Re: ROL01116 – Planning Application Reference HGY/2023/1406 at 10 Ellington Road, London, N10 3DG – Daylight and Sunlight – 12D Ellington Road – Objection

Anstey Horne have been instructed to review the details of the proposed scheme submitted with the planning application HGY/2023/1406, and its potential adverse daylight and sunlight effects on 12D Ellington Road.

Fig.4

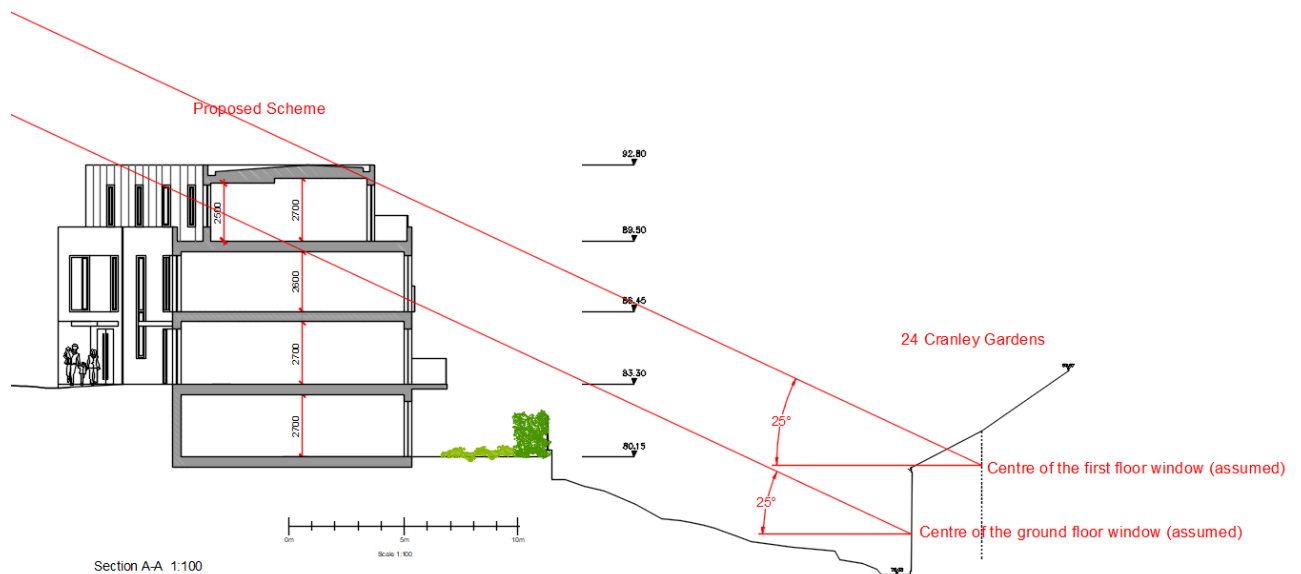
Lastly, we note that the Design and Access Statement dated May 2023, prepared by Jane Duncan Architects and Interiors, indicates that the proposed development would be a sufficient distance from the built form of No. 20 - 26 Cranley Gardens, in order to avoid material loss of light. We have been asked to review this finding and we have found that the ground and first floor windows within No. 20 - 26 Cranley Gardens do breach the 25 degree section, an example of which is illustrated in the Fig.4 below. Therefore, according to the BRE guide (2022 edition), these properties should also be considered further and included in a full technical study.

We are of the opinion that the information provided by the Applicant is not complete at this stage and the Council is advised to request the full technical daylight, sunlight and overshadowing assessment and report to be provided so that the actual impact on the neighbouring properties is properly understood. Furthermore, upon submission of the additional elements, we would request a period of further consultation which would allow us to comment on the amended report if needed.
